METROPOLITAN GOVERNMENT OF NASHVILLE AND DAVIDSON COUNTY

STAFF RECOMMENDATION
2010 18th Avenue South
April 17, 2013

Application: New construction-infill; Setback reduction
District: Belmont-Hillsboro Neighborhood Conservation Zoning Overlay
Council District: 18
Map and Parcel Number: 10412025900
Applicant: Will Jenner/ Jenner Design LLC
Project Lead: Robin Zeigler, robin.zeigler@nashville.gov

18TH ELEVATION

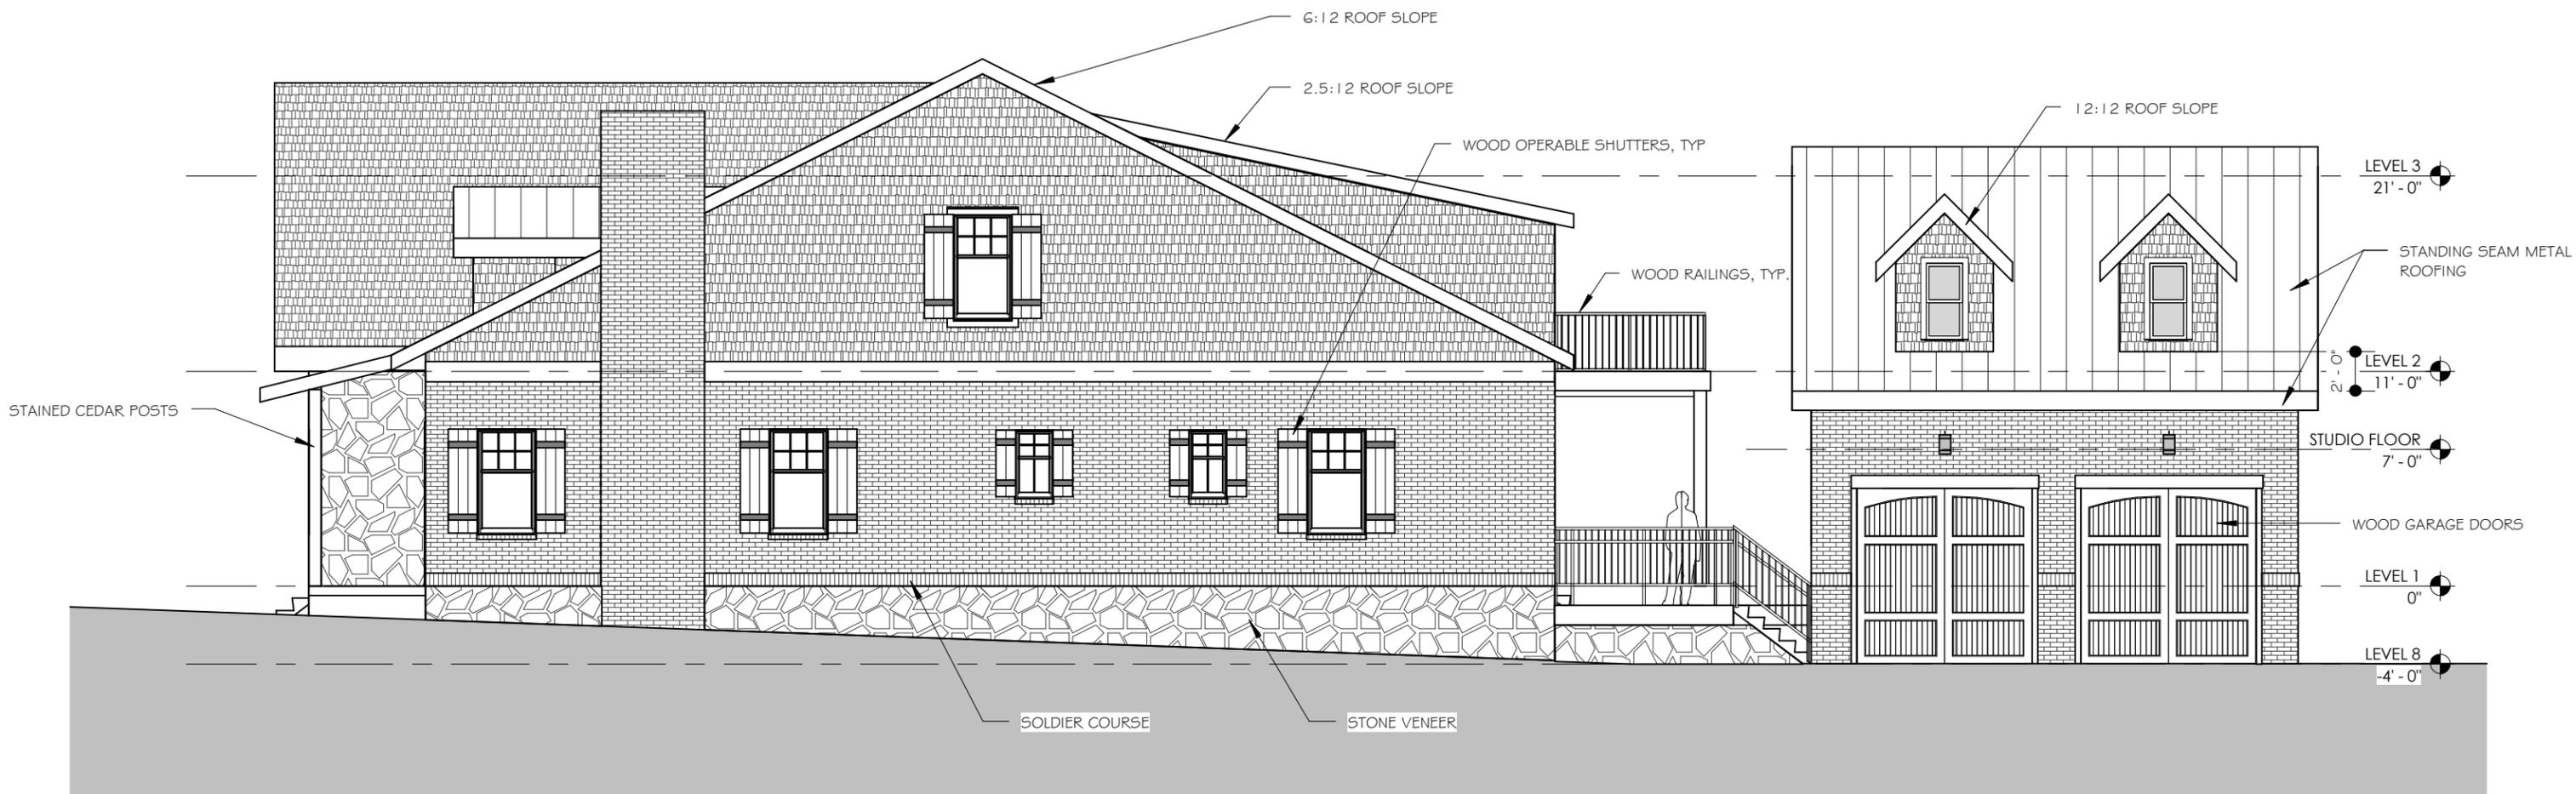
Materials, Texture, Details, and Material Color: The foundation is stone, the cladding brick, stone and cedar shakes and the roof is asphalt shingles and standing seam metal, colors unknown. The main entrance is a porch with a concrete floor, wood posts and solid wood door. The shutters are wood but the window material and design is not indicated. The chimney is brick and the rear porch is wood. The trim and garage door materials are not indicated. Staff recommends final approval of windows, doors, trim and

roof colors and that the shutters have hinges and dogs, rather than being installed flat against the wall. With these conditions, the project meets section II.B.d of the design guidelines.

Proportion and Rhythm of Openings: The windows are twice as tall as they are wide and meet the historic context. Typically the Commission has required a minimum of eight to thirteen feet (8'-13') between windows to meet the rhythm of openings found in the overlay. Staff recommends an additional window on the left side in the kitchen area to meet this criteria. As this is likely the location of upper kitchen cabinets, a shuttered window, would be appropriate. With the condition that a shuttered window be added to the left side, the project meets section II.B.g of the design guidelines.

- Applicant submits additional information about windows, doors, trim and roof colors for final staff review;
- A shuttered window be added to the left side;
- Shutters have hinges and dogs, rather than being applied against the wall;
- The outbuilding be reoriented so that vehicular access is from the alley;
- Windows be added to the street facing side of garage (if reorientation of the garage is a condition);
- The height of the garage be lowered by one foot (1'); and
- Utility locations be located beyond the midpoint of the house.

BERNARD ELEVATION

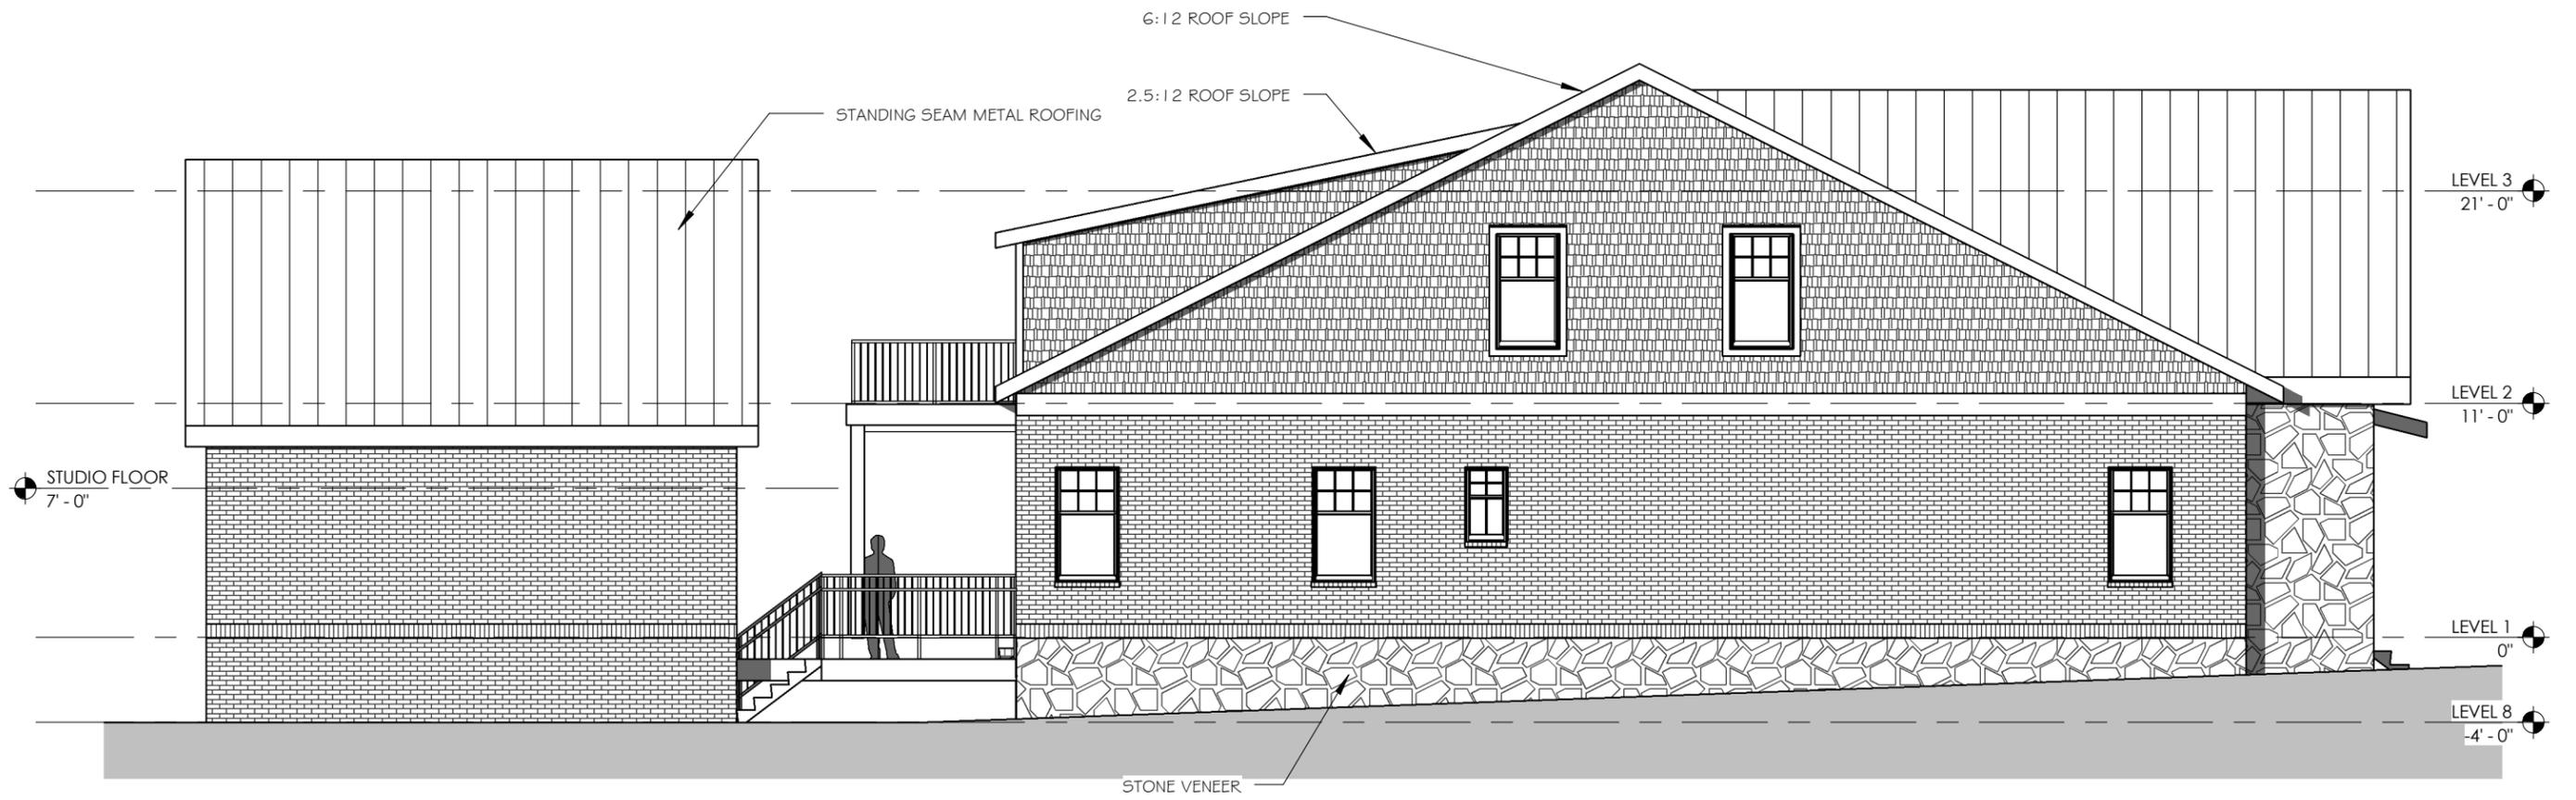
The garage is oriented towards Bernard Street; however, there is a rear alley. Staff recommends that the vehicular entrances to the garage be oriented towards the alley as historically found in the district. Orientation towards the alley would also eliminate the need for a twenty-five foot (25') wide driveway on Bernard Street. The home across the street has a garage oriented towards Bernard Street; however, the garage is only a one-car garage which allows for a narrower driveway.

Roof Shape: The roof is a side gabled building with a steep pitch of 12/12 and two gabled roof dormers. Although the pitch is not similar to the main building which is 6/12, it is a typical roof form for the district. The guidelines recommend that street facing dormers have a minimum of a two foot setback from the wall. The proposed dormers only have a one foot setback; however, if the garage is reoriented towards the street, as recommended, to address orientation and driveway width incompatibilities, the dormers will be appropriate. Staff recommends reorienting the garage towards to the alley and adding windows to the street facing side.
